**INVER GROVE HEIGHTS
PLANNING COMMISSION AGENDA
TUESDAY, OCTOBER 5, 2021 - 7:00 p.m.
City Council Chambers - 8150 Barbara Avenue**

3.03 AT HOME APARTMENTS - CASE NO. 21-45PUD

REQUEST: Rezoning, Preliminary Plat and Preliminary PUD Development Plan

Sheet No. Revision
C3.01

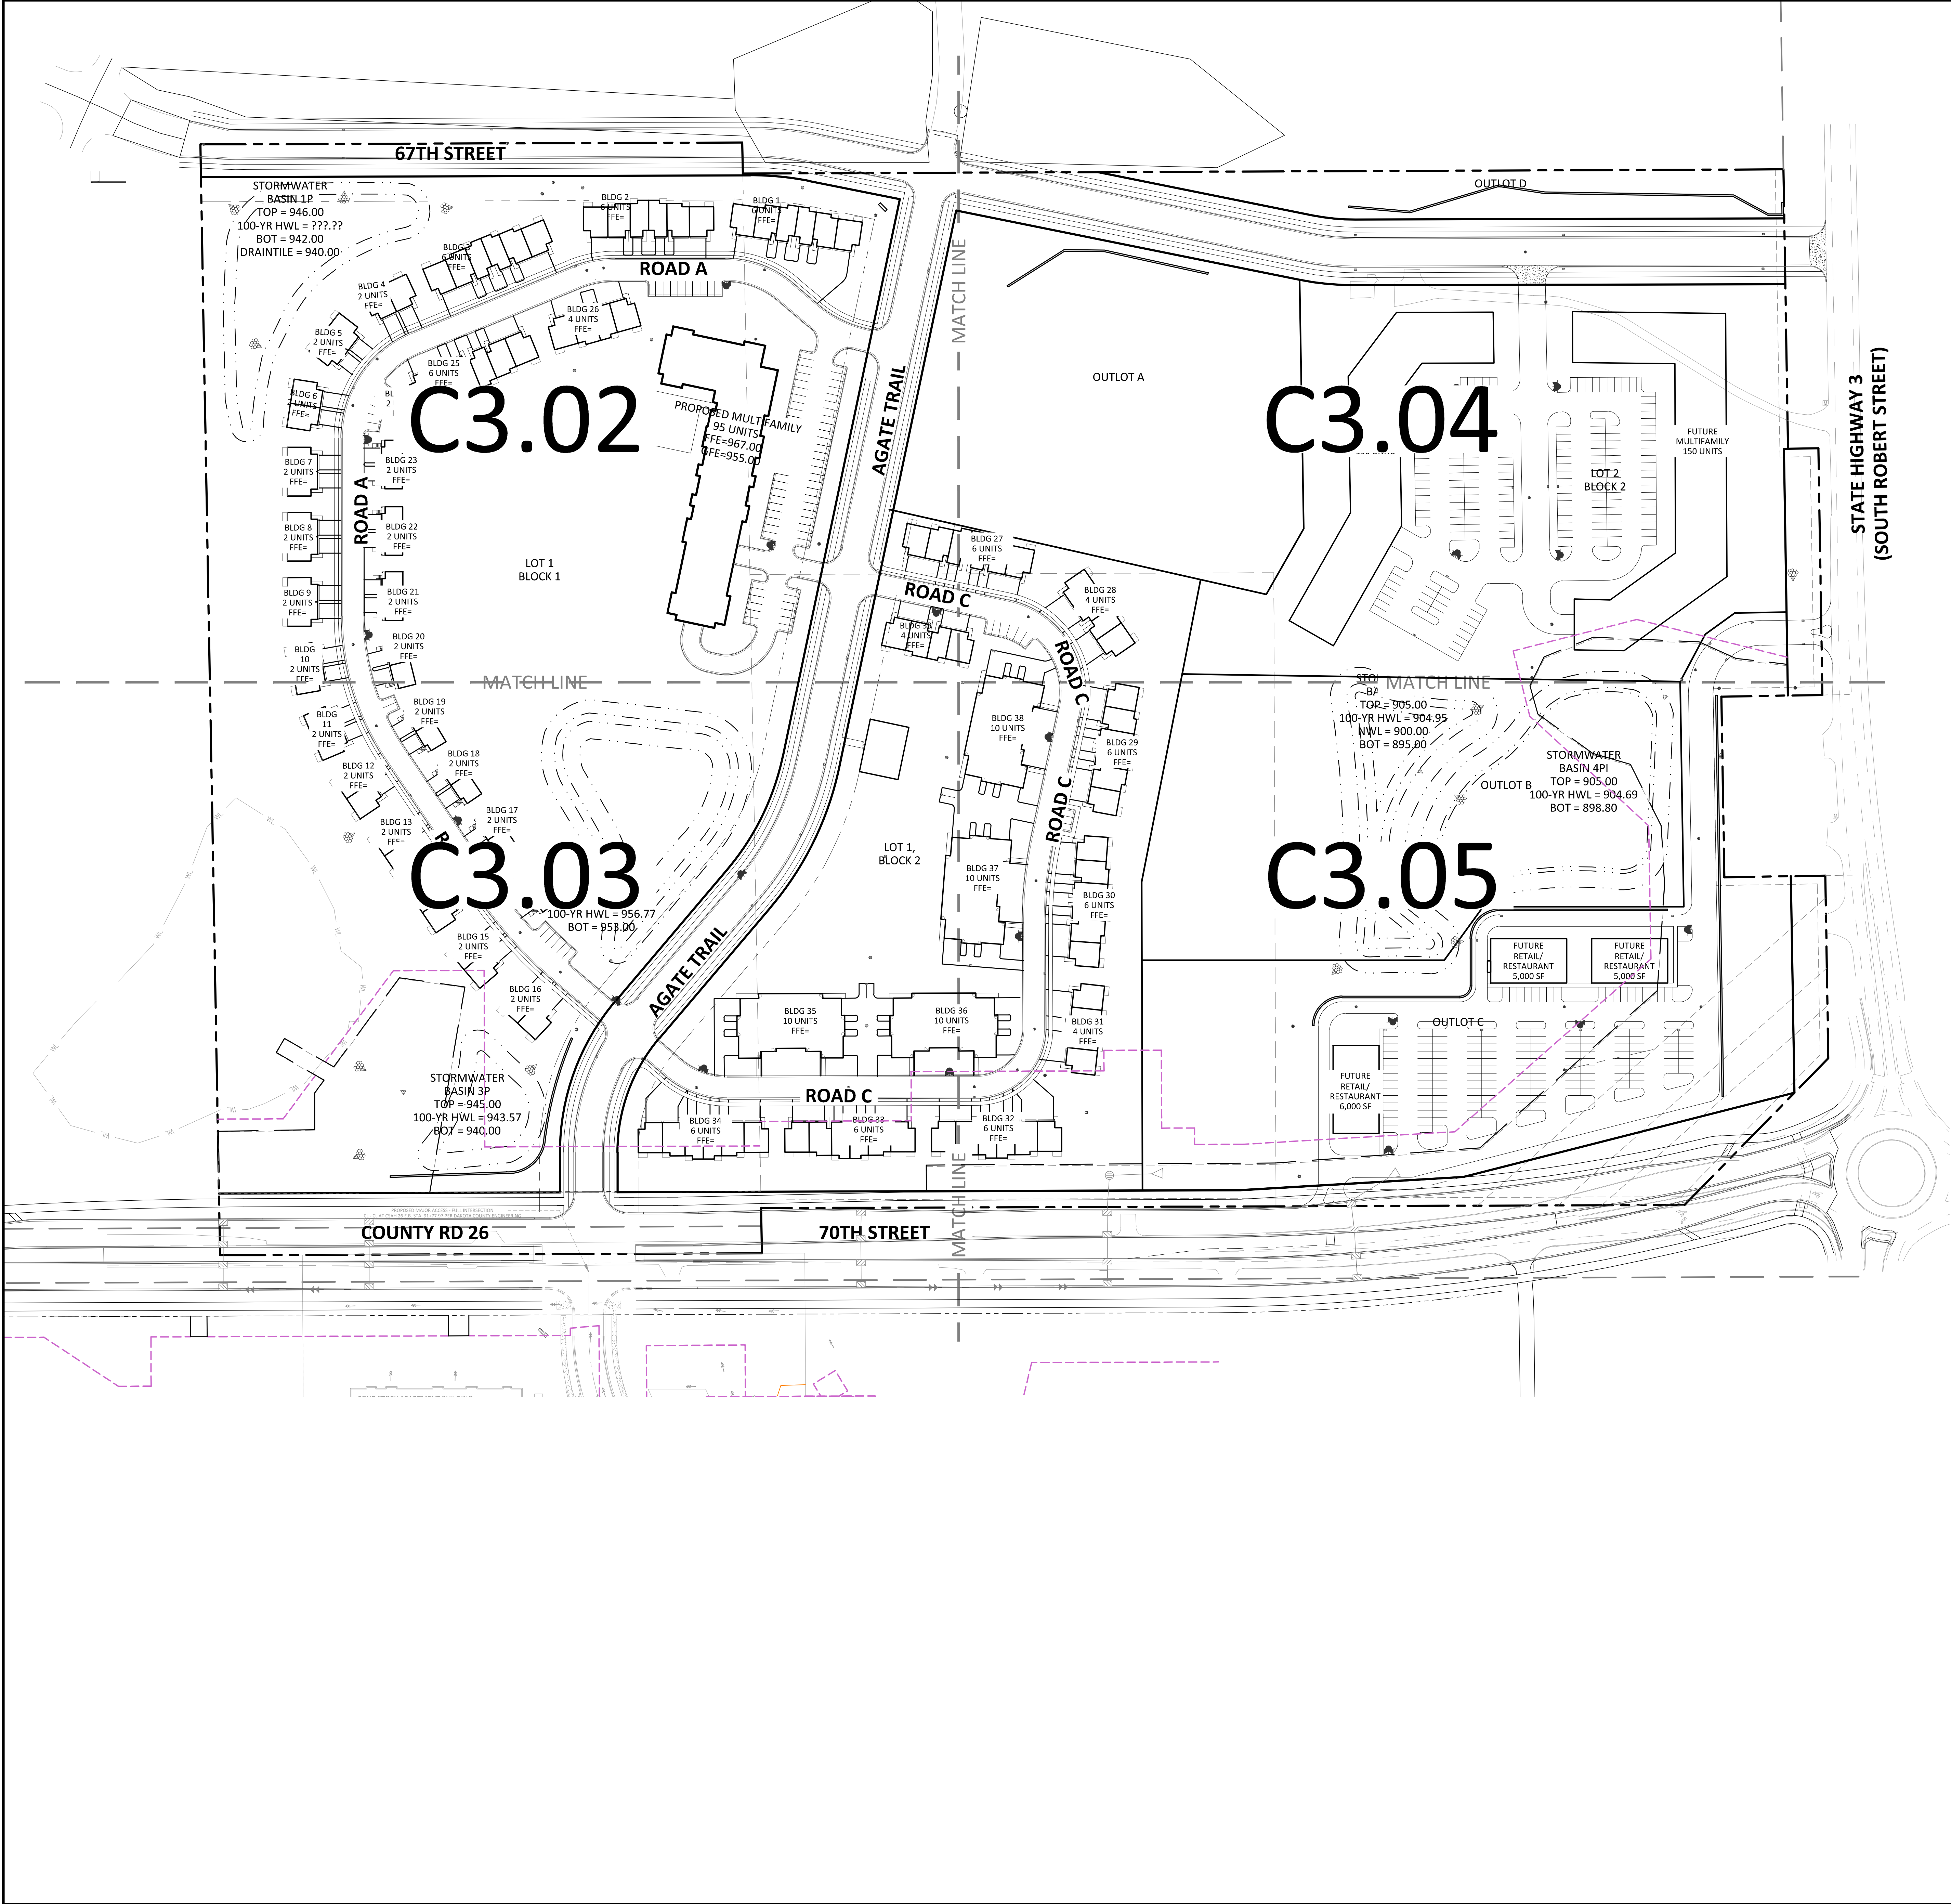
The proposed setbacks for the project are listed on the plan sheet Overall Site Plan (Sheet C3.01).

It appears there is room for 20 feet between buildings 19 and 20 with some slight changes to other building locations to meet requirement. Staff recommends plans be changed to meet requirement.

The buildings along 70th Street were at the same setback on the original plans, they did not change with the revised plans. The Crossings project was approved with a 20 foot setback along 80th Street (arterial street) for the apartment building and setbacks in the 30 foot range for the townhomes. Projects with lesser setbacks have been approved in the past and staff feels an encroachment of 10 feet into the setback for backyards of buildings 32,33 and 34 should be supported based on past approvals.

17. A traffic study shall be required to be submitted by the applicant and reviewed by the city to verify trip generation and traffic routing.
18. The required 20 foot separation between buildings 19 and 20 shall be met on the final plan set submittal.

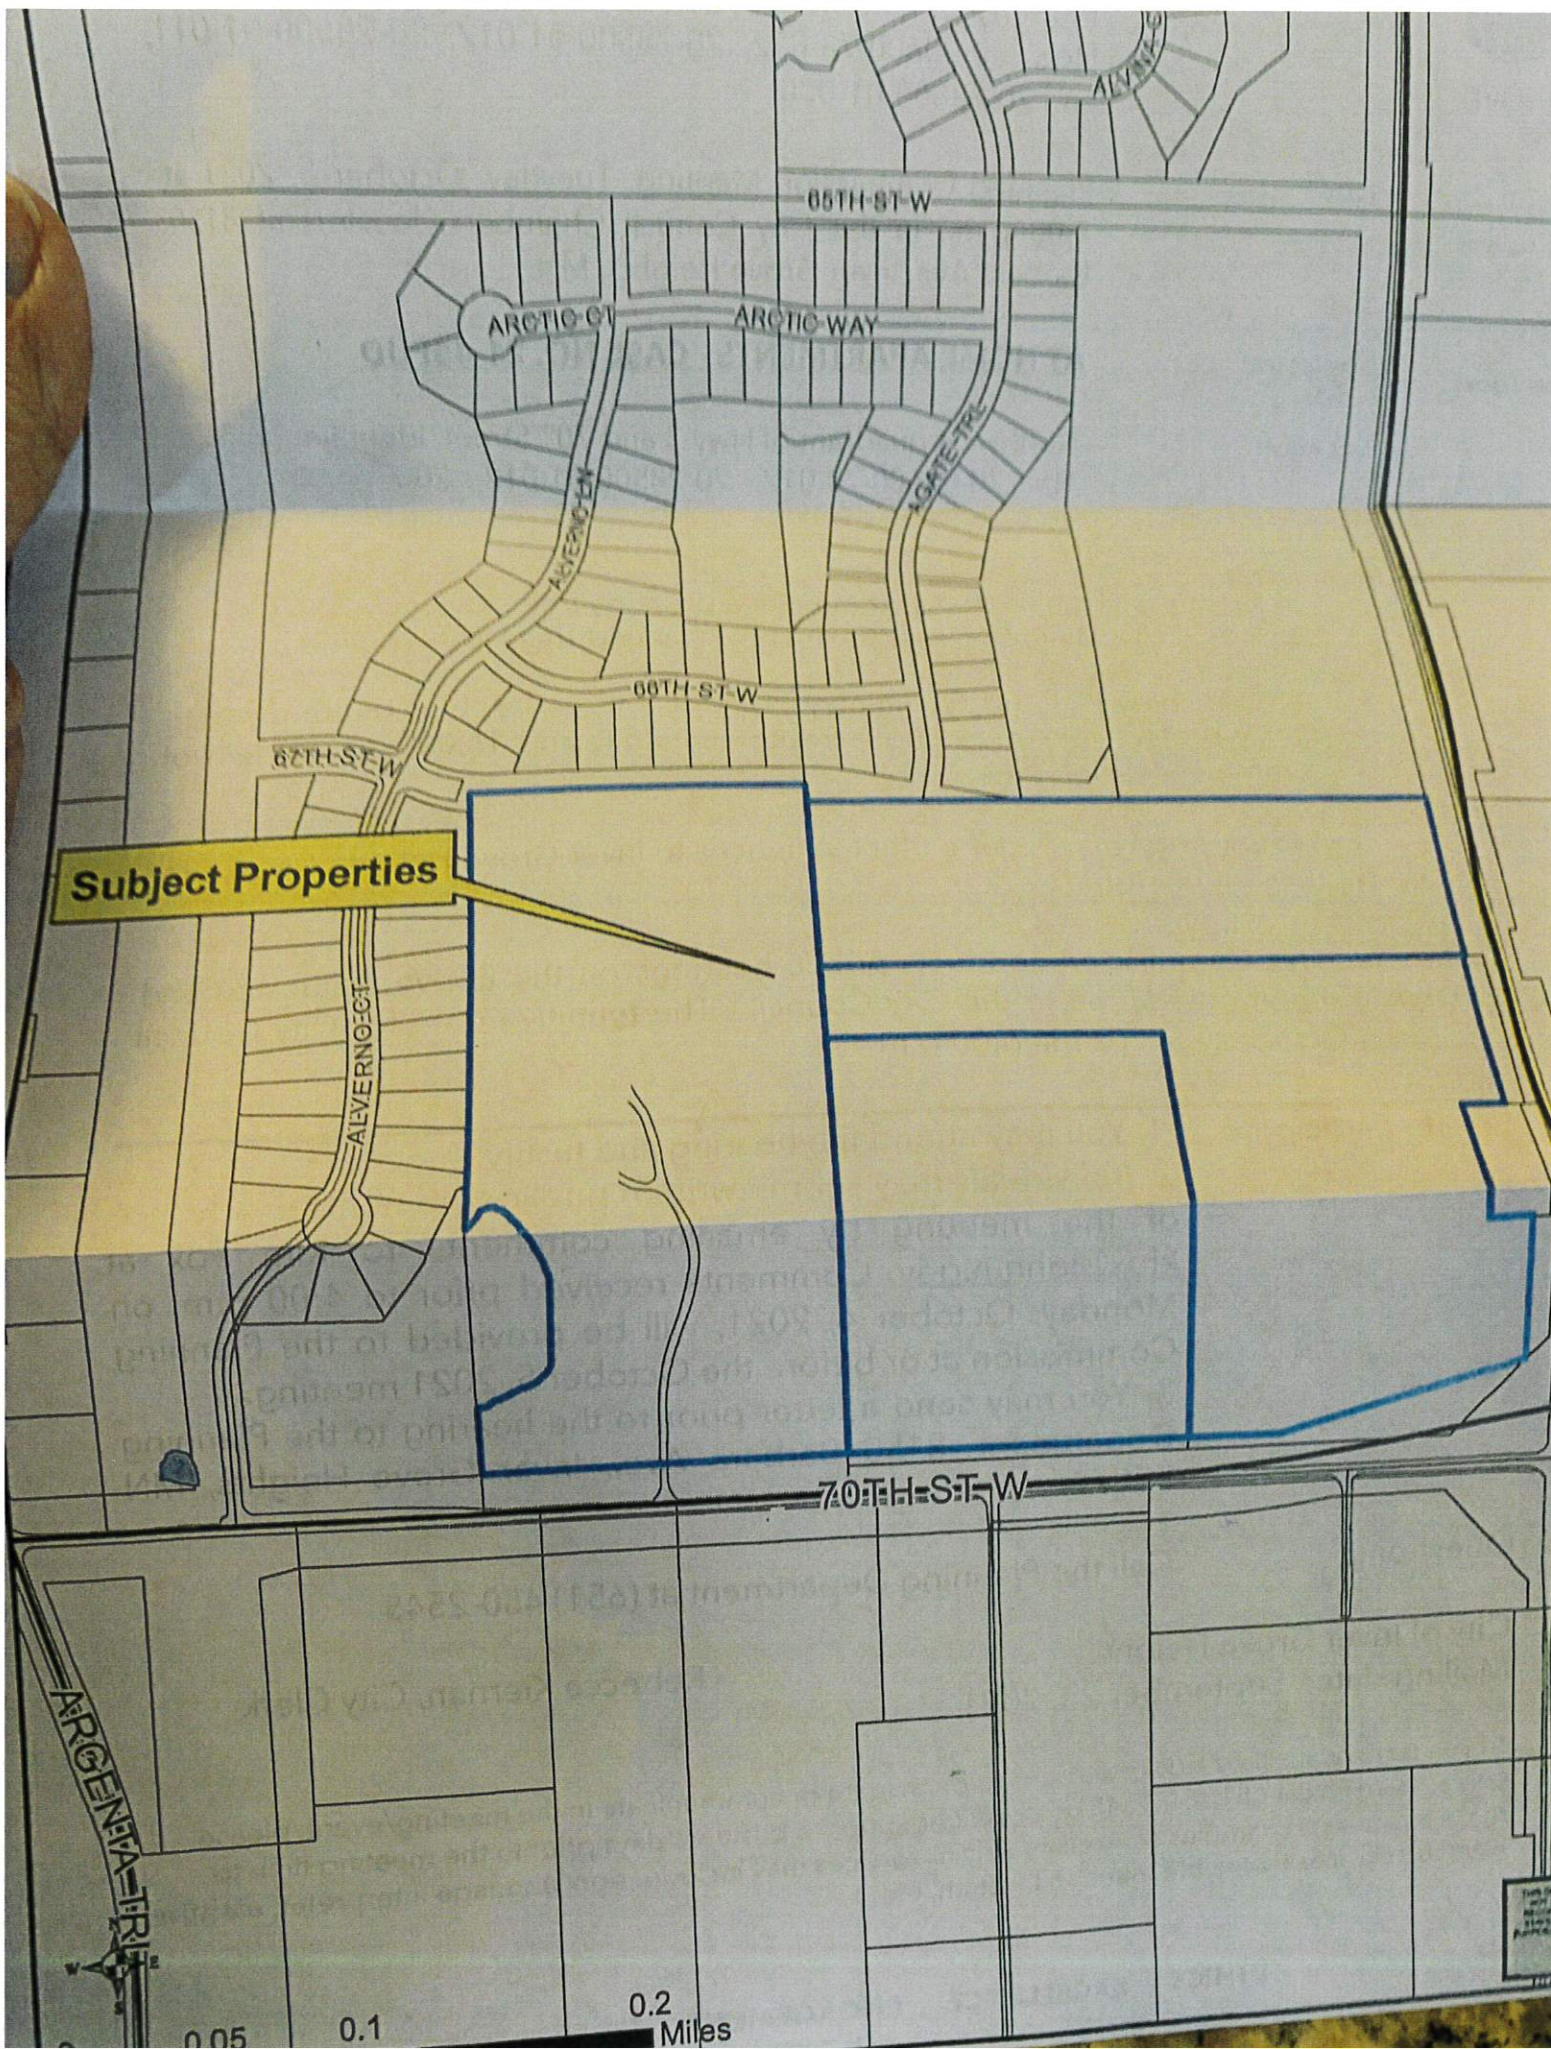
I am submitting input for the Oct 5th meeting. I have attached the map from the proposal as well as the relevant pages from the 2040 Comprehensive plan. This is the data that many of Settlers Ridge residents including us had available to make a purchasing decision.(2017 for us). The 2040 comprehensive plan shows that the ONLY area of high density(R-3C) is at the corner of 70th & Hwy 3 and not further north and west closer to the Settler Ridge houses. I think the Planning Commission should follow the 2040 comprehensive plan and not modify At Home's request to change the location of where the high density R-3C is. The surrounding area just south and east of the Settlers ridge houses should stay either low medium density or medium density as documented in the 2040 plan.
